REMARKS

4/6

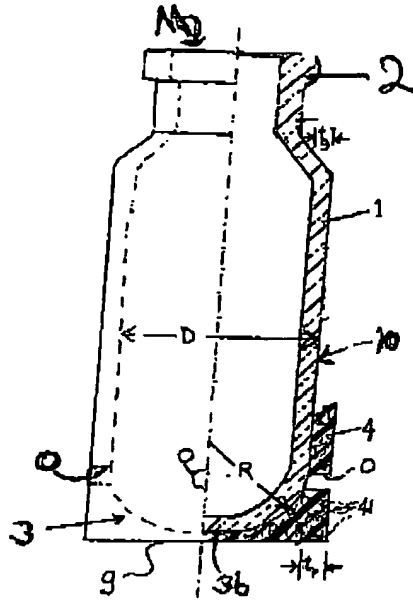
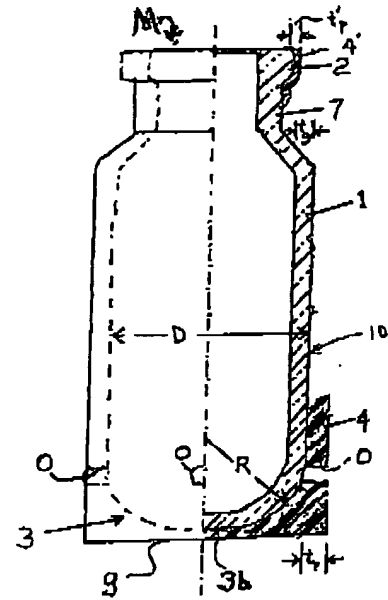
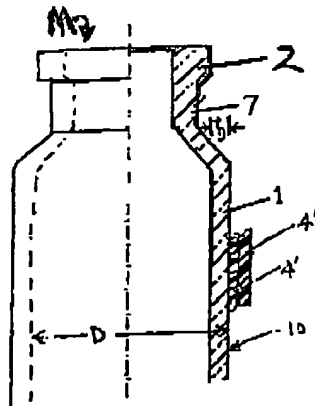
Fig. 4 was objected to under 37 C.F.R. 1.84(h)(5) because figure 4 showed several different embodiments on the same figure.

A sketch of a proposed drawing correction of this sheet of the drawing, namely 4/6, has been provided. Figure 4 has been divided into three figures 4a, 4b and 4c each showing the three different embodiments separately.

Also the descriptions of fig. 4 in paragraph 56 of the substitute specification filed January 19, 2004 and paragraph or section 46 have been changed accordingly.
